1 Products affected

2 Type of change

Product Change Notification					PCN OGN 2nd Production Site		
owner	creation date	release date	released by	change order	rev	page	D10-070-757
zeierjo	18.01.2023	20.01.2023	schulejo	2025354	A	1 of 2

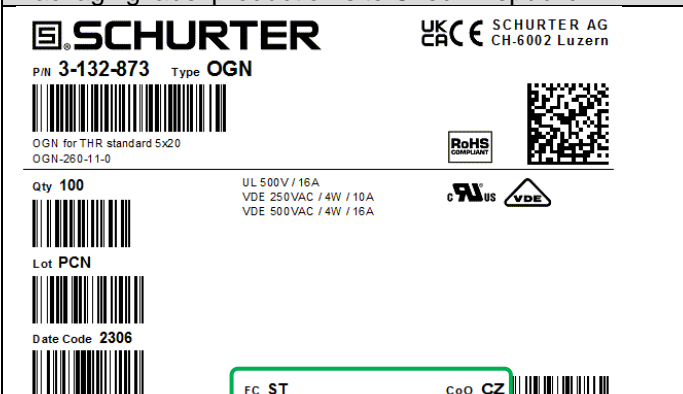
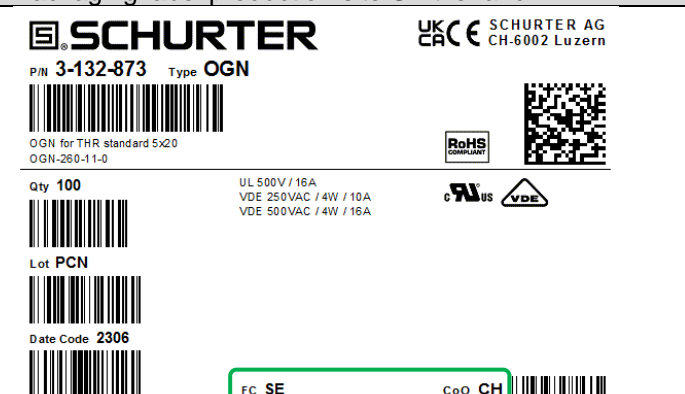
- Country of origin (CZ or CH) and factory code (ST or SE) change, depending on the manufacturing site.
